UNITED STATES PATENT AND TRADEMARK OFFICE

09/863,586

Office Action Summary

Detailed Action

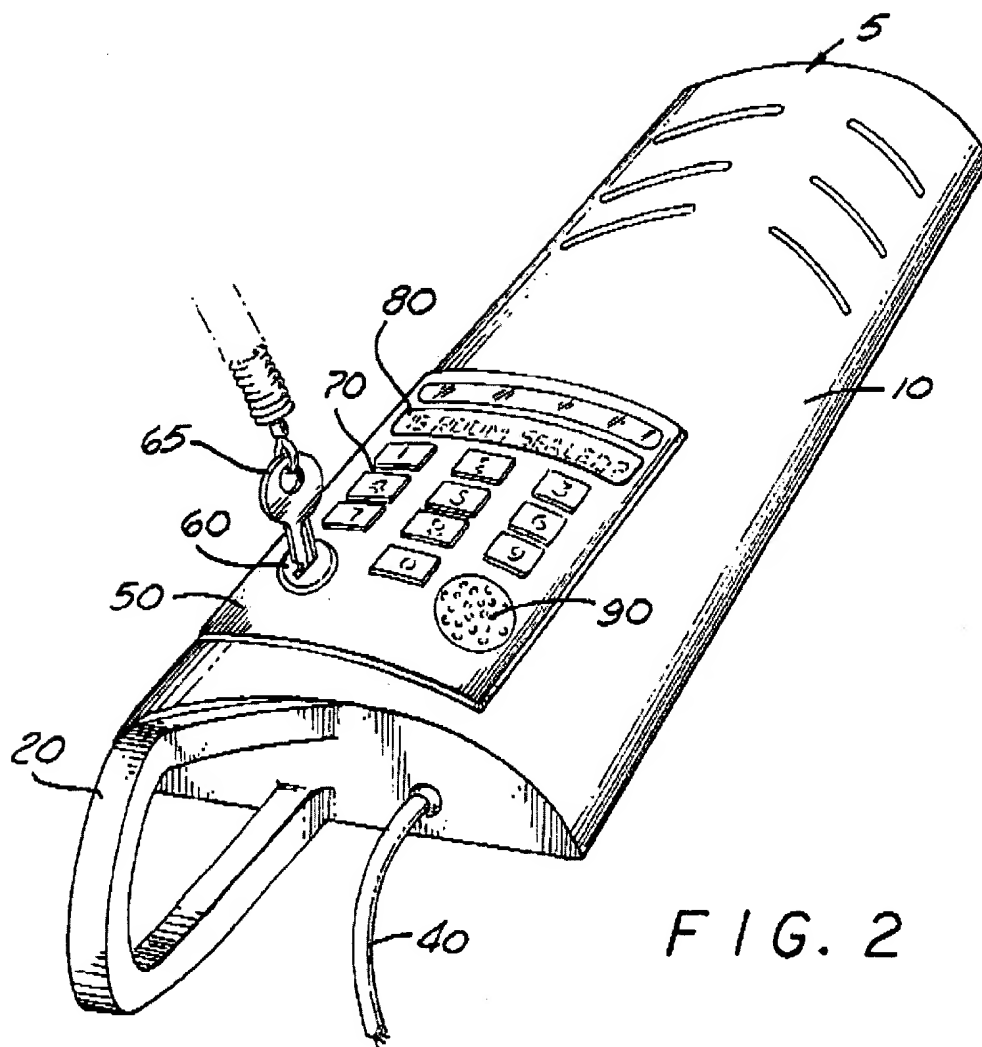
Whitehead (075) clearly discloses in FIG. 2 a perspective top view of the hand-held sterilization device 5 that includes a housing 10, a handle 20 coupled to the housing, and a power cord 40 that may be connected to a power source. The device 5 in FIG. 2 further includes an electronic safety mechanism 50. The electronic safety mechanism 50 includes a switch lock 60 actuated by a key 65. The electronic safety mechanism 50 also includes a digital lock circuit made up of a numerical or alphabetical keypad 70 wherein a required numerical or alphabetical code is needed to

open or turn on the power to the digital lock circuit. See Column 3, line 55-61; Column 4, line 25-46; and Figure 2 below.

It is implied in Figure 2 that the use of a key 65 to access the lock 60 and thereby moving the safety switch between on and off in accordance with Whitehead (075), is equivalent to physically obstructing finger access as recited in Claims 1, 2, and 13.

It is also implied herein that inserting and turning the key 65 in the safety switch 60 in accordance with Whitehead (075), is equivalent to an activation tool adapted to engage the tool engaging portion of the safety switch, as recited in Claims 1-3, 13, and 16.

It is further implied herein that prior to inserting and turning the key 65 in the safety switch 60, a finger is physically prevented from access to the switch. Thereafter, using the finger to turn the key, which then allows finger access to the keypad switch in accordance with Whitehead (075) is equivalent to "means moved to a first position and allowing finger access to the switch when the means is moved to a second position, as recited in Claim 12.

It is still further implied that the safety switch 60 is equipped with a cover, and an opening, as well as, a plate, and a back plate in the interior body (not shown in Figure 2). As a result the use of the switch 60 for engaging the key 65 in accordance with Whitehead (075) is equivalent to the switch cover having an opening therein adapted to allow the passage of an activation tool, as recited in Claims 16-18.
